July 2, 2015
	Alberta Technology Center
Owner:	The City of Tuscaloosa
Owner's Project No:	A15-0513
Architect:	Ward Scott Architecture, Inc.

Addendum No. 3 - Structural Items

14 / S002 **SECTION**

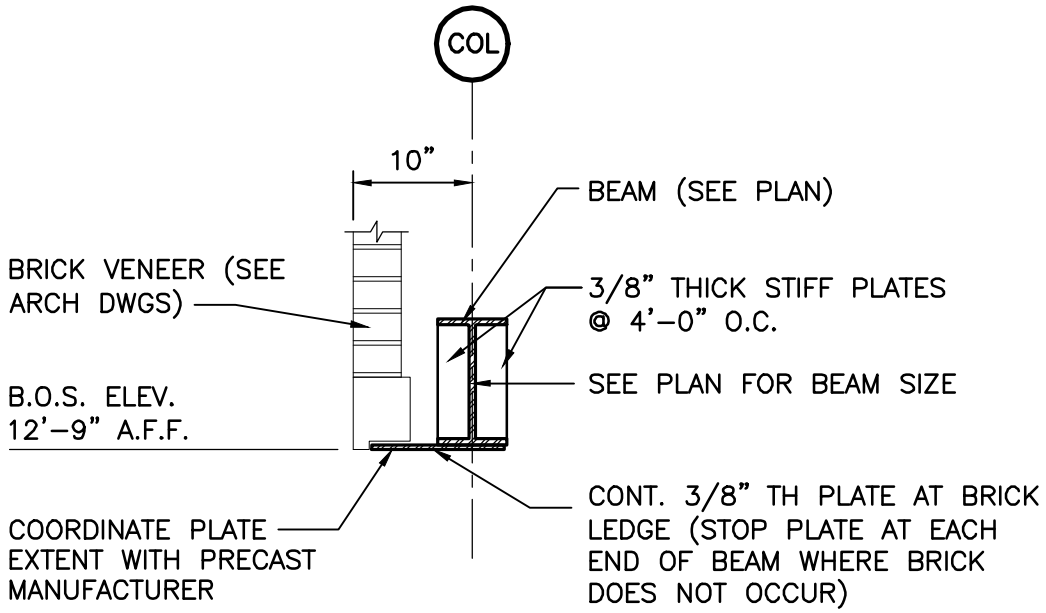
1. Revised bottom of steel elevation and clarified bottom plate extents on section 14/S002. Reference the attached supplement drawing SD-1.

4 S003 SECTION
SCALE: N.T.S.

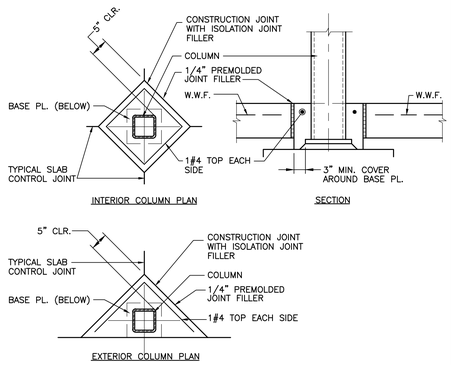
2. Revised dimension on detail 4/S003.

9 S003 SECTION
SCALE: N.T.S.

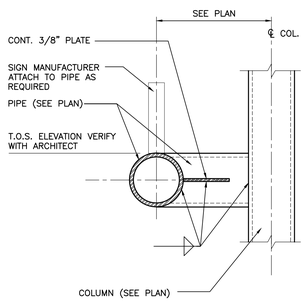
3. Revised pipe designation on detail 9/S003.

S104

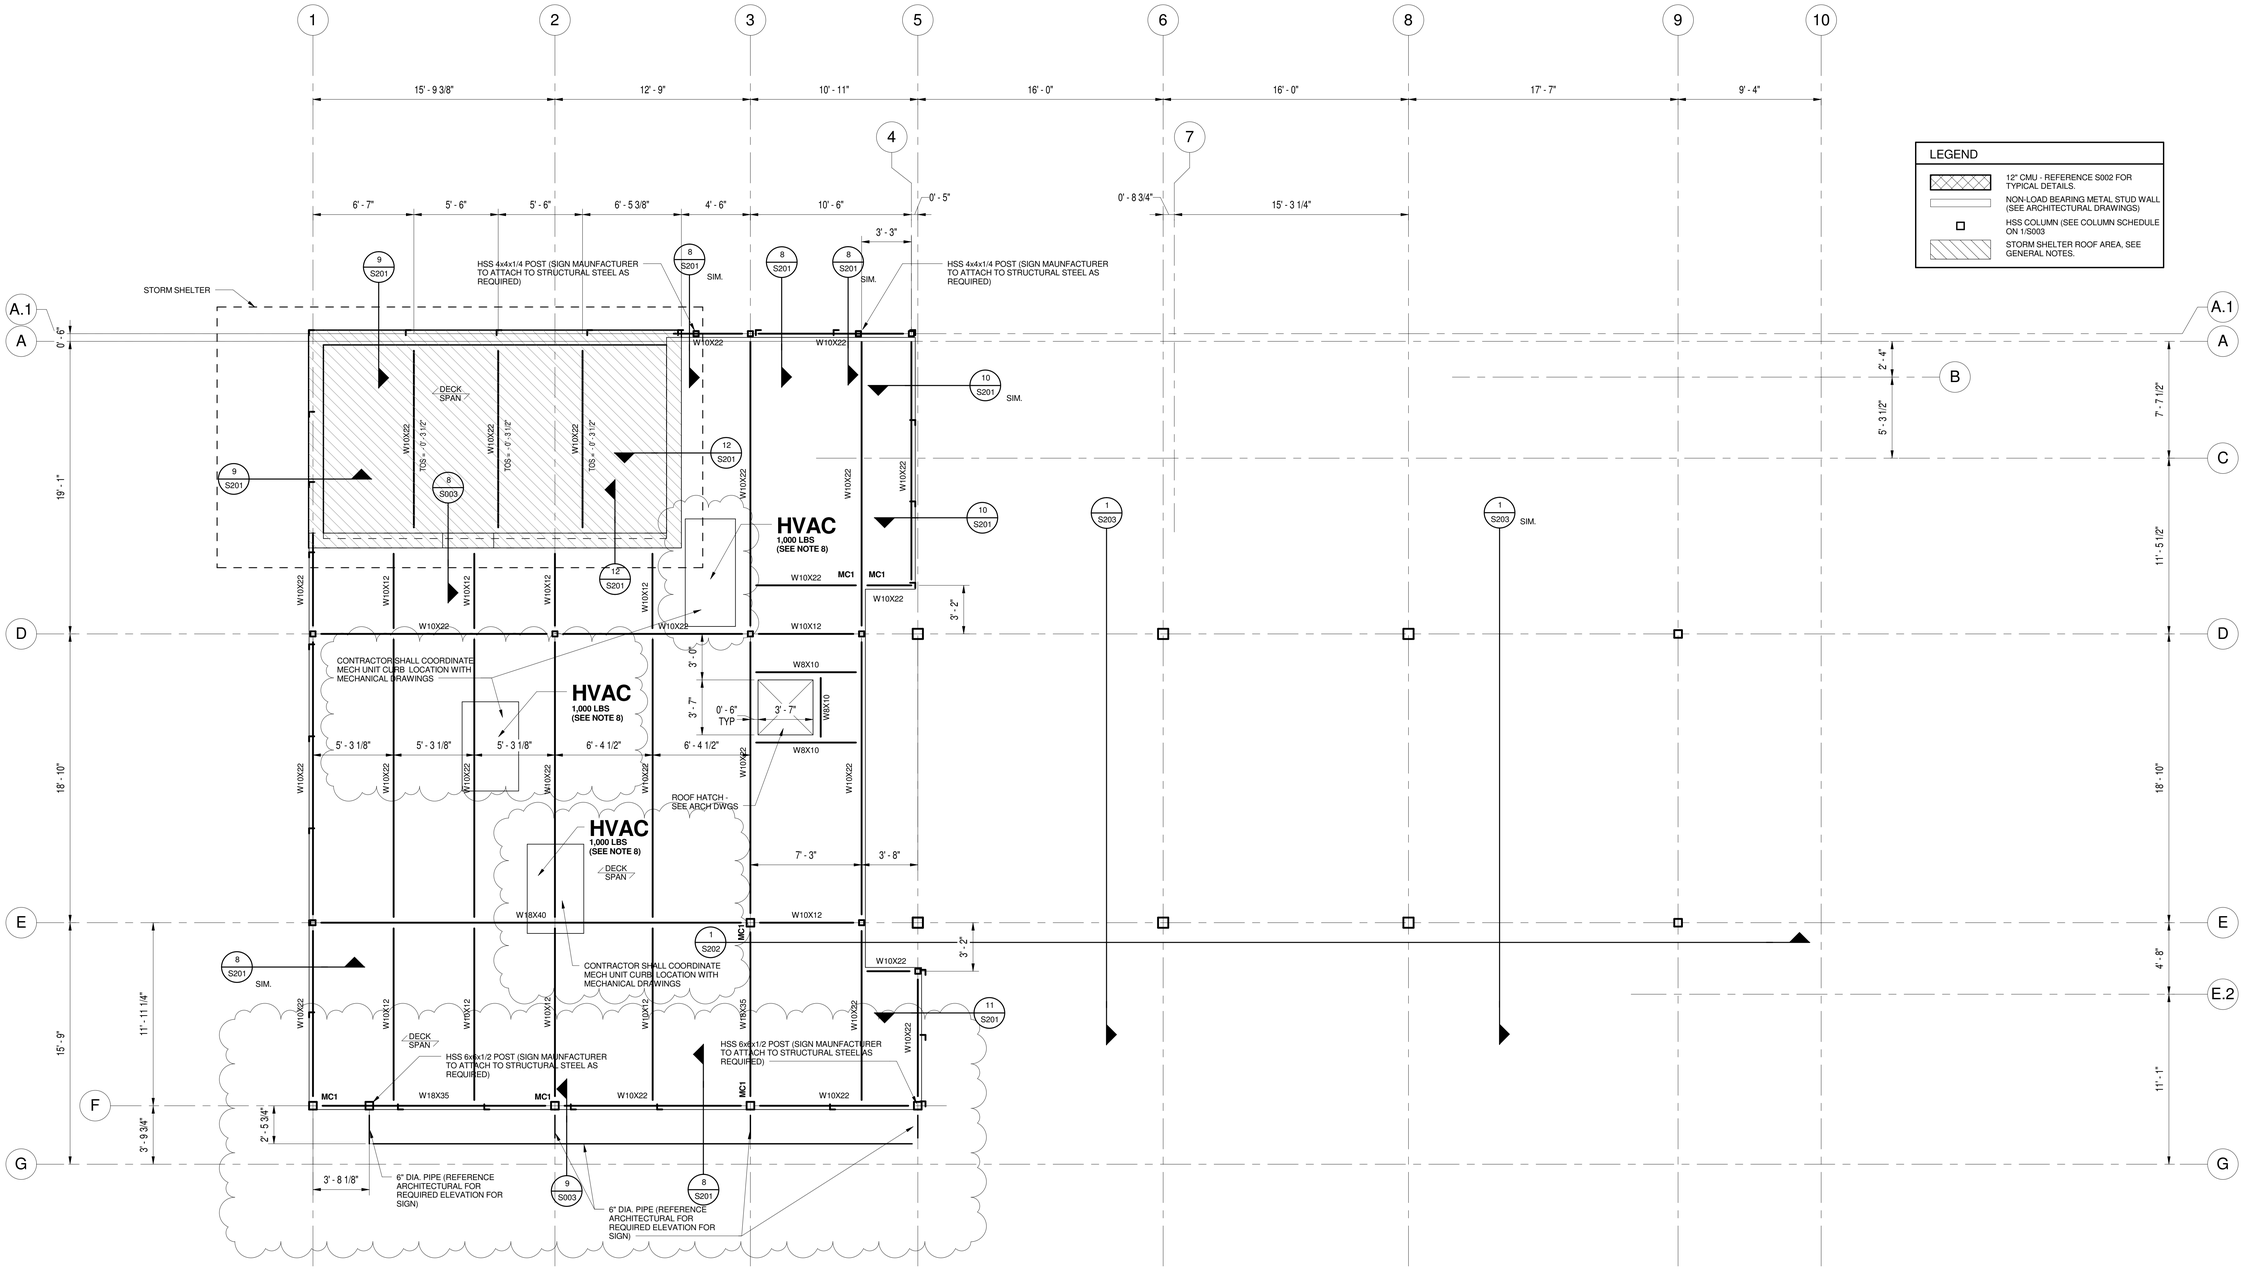
II. Sheet S104 – High Roof Framing Plan

1. Revised sign support extents.

2. Revised roof-top mechanical equipment locations and added notes for contractor to coordinate the mechanical curb support and locations with the mechanical drawings.

1 SECTION
S202 1/2" = 1'-0"

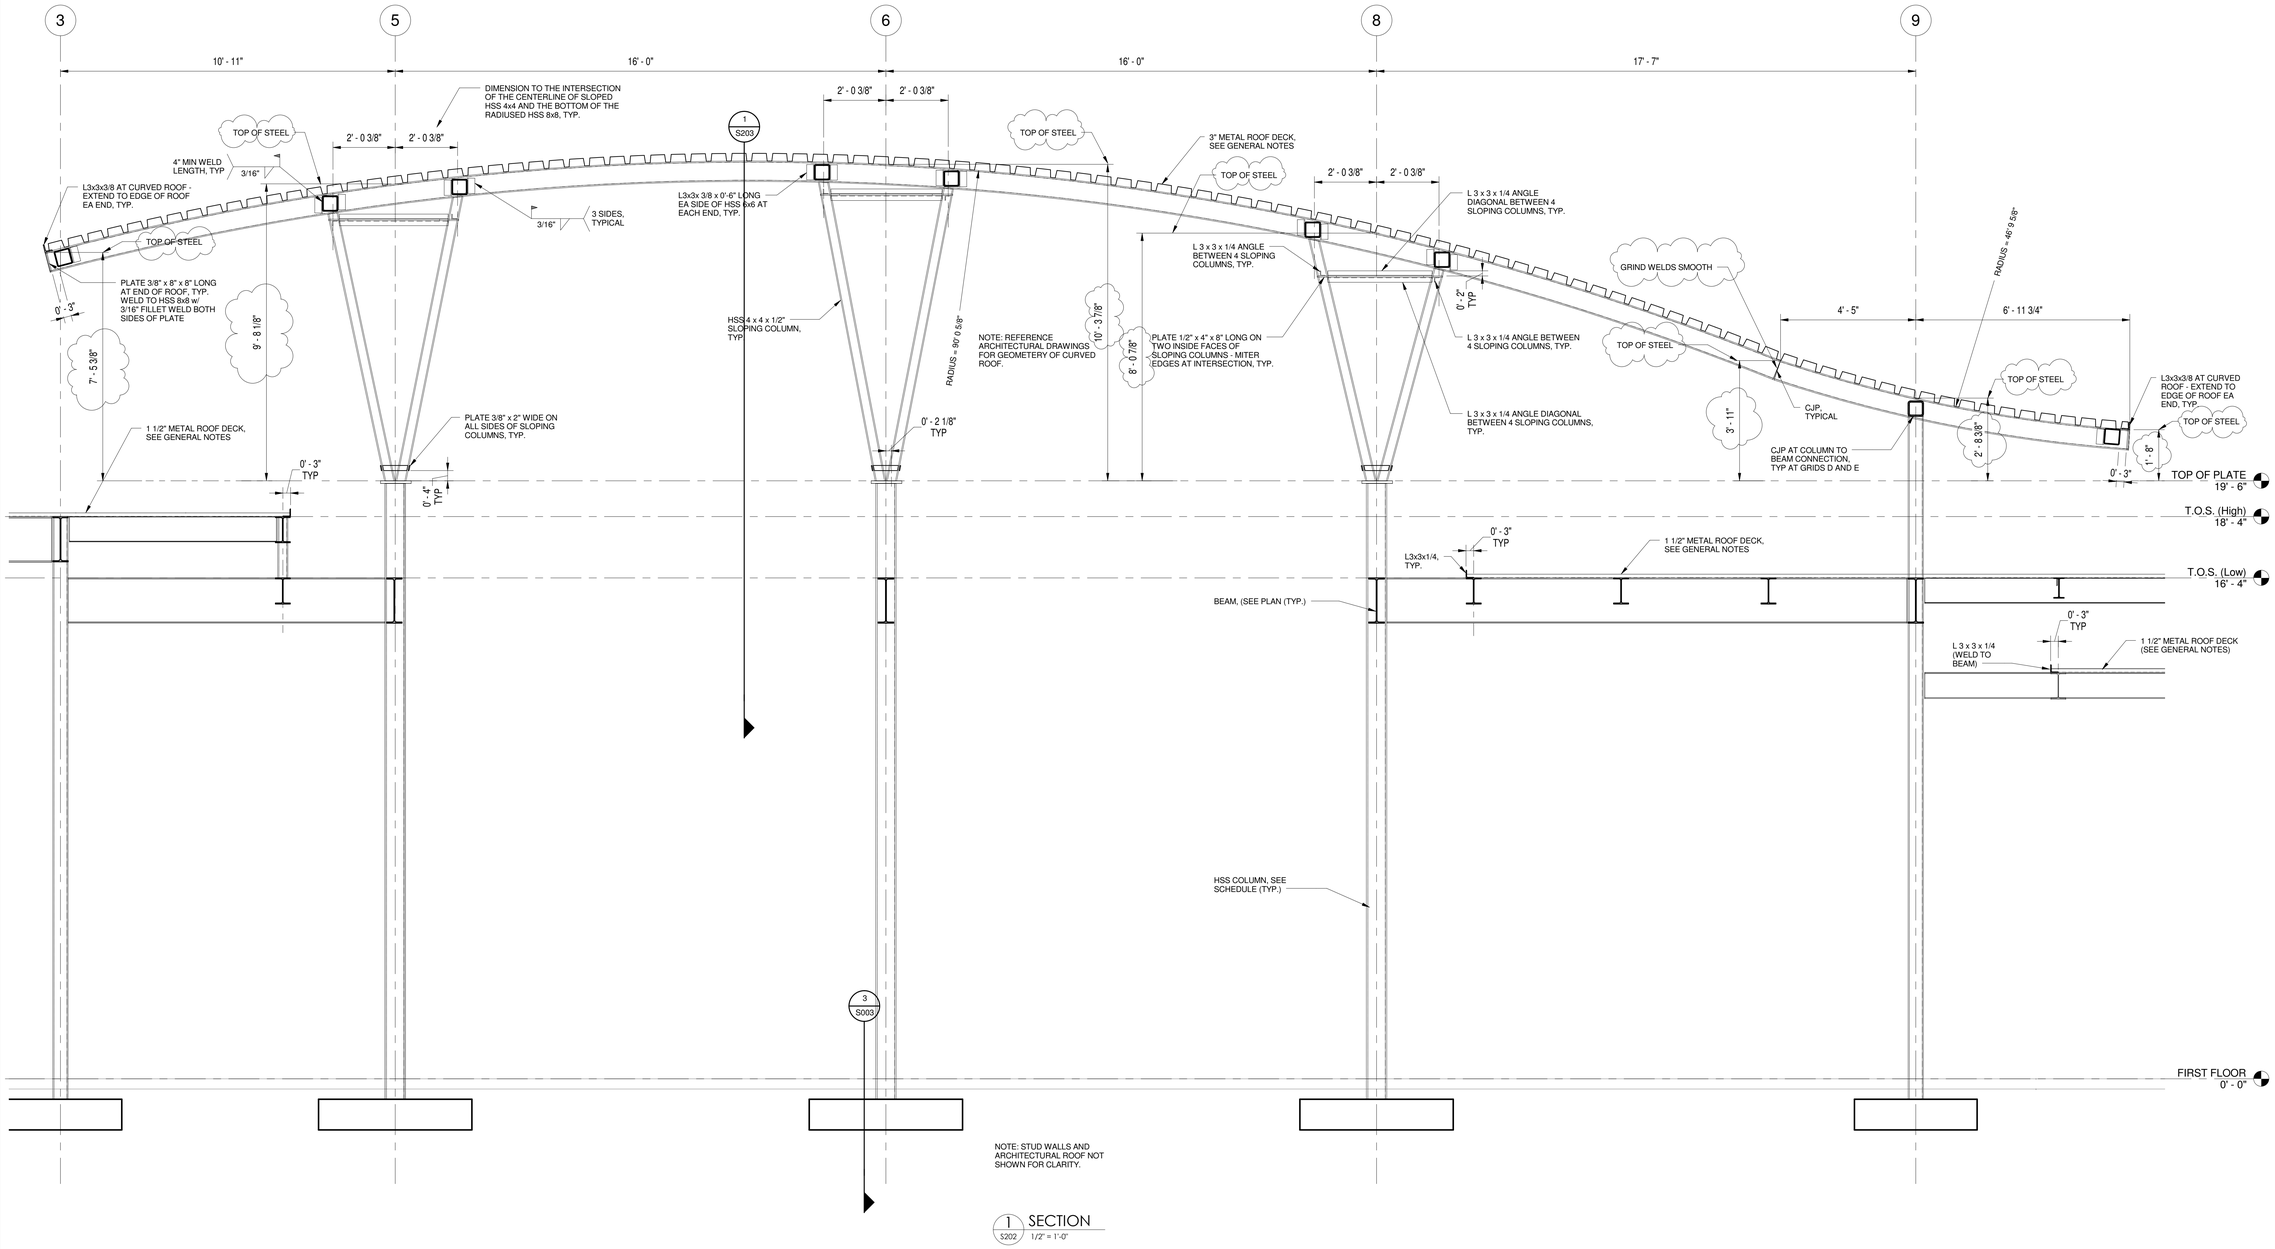
III. Sheet S202 – Sections

1. Added dimensions at curved structural members.

1 SECTION
S203 3/4" = 1'-0"

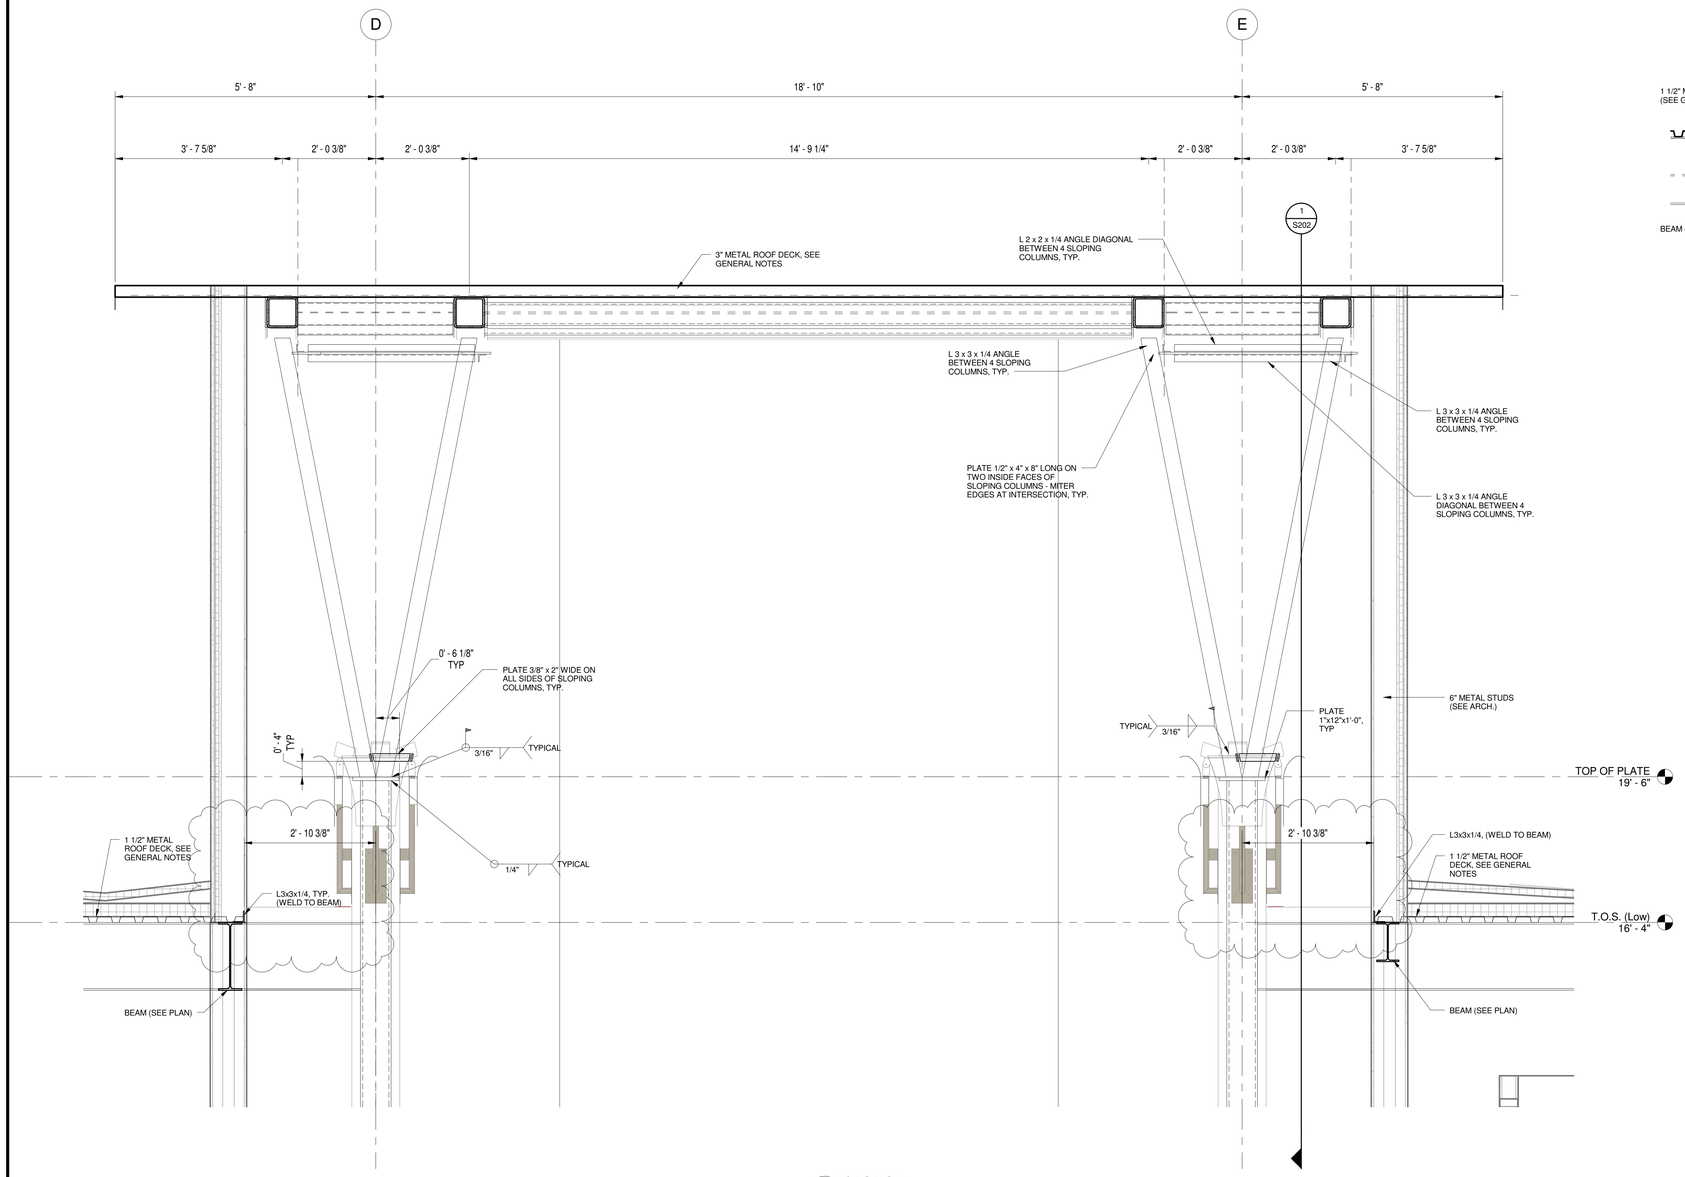
1. Revised edge angle locations on section 1/S203.

2 SECTION
S203 3/4" = 1'-0"

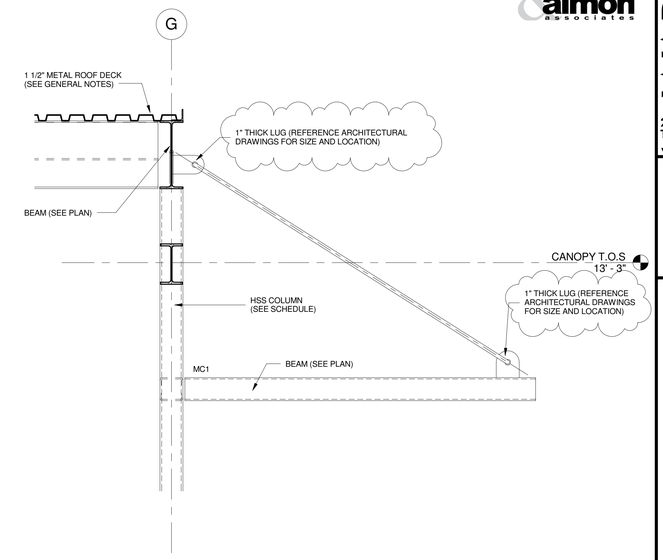
2. Added note to 2/S203 for the contractor to reference the architectural drawings for the size and location of the 1" thick lugs.
